E4416A-17 <u>S E R V I C E N O T E</u>

E4416A EPM-P Single Channel Power Meter

Self-Test 'Display Assy.' report false failure with firmware version A1.05.01

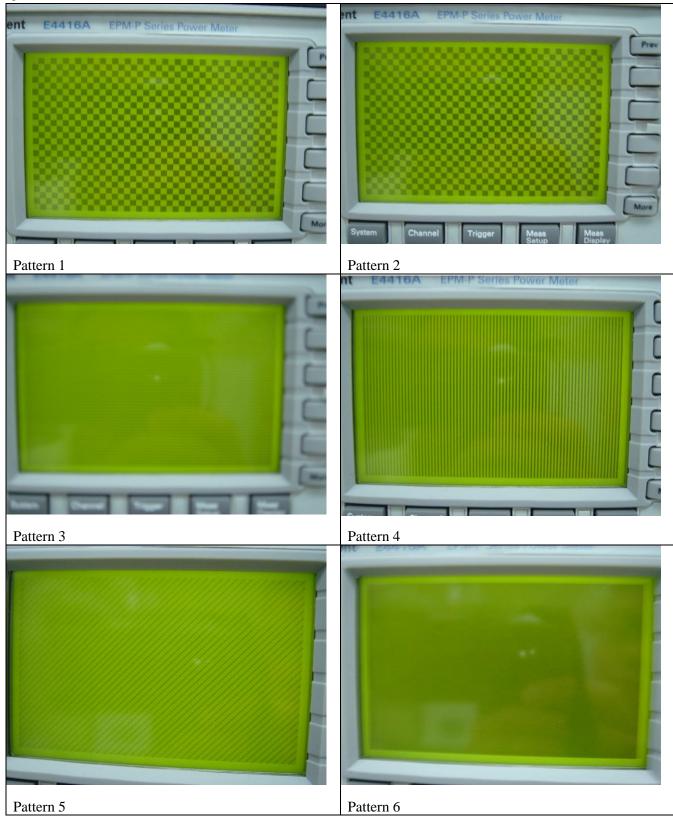
3. You will get 7 patterns as shown as below.

4. Check pixels on display screen, if all the pixels are able to show bright or black color as shown in the screenshots below, then the Display Assy. failure was due to mismatched of firmware version

A1.05.01 with new IC controller. This means the self test indicated a false failure and the display assembly is actually working.

5. Proceed to perform firmware upgrade to A1.05.02 (or above).

6. If there is a failure on the bitmap pixels on step #4, then contact nearest Agilent Service Center.
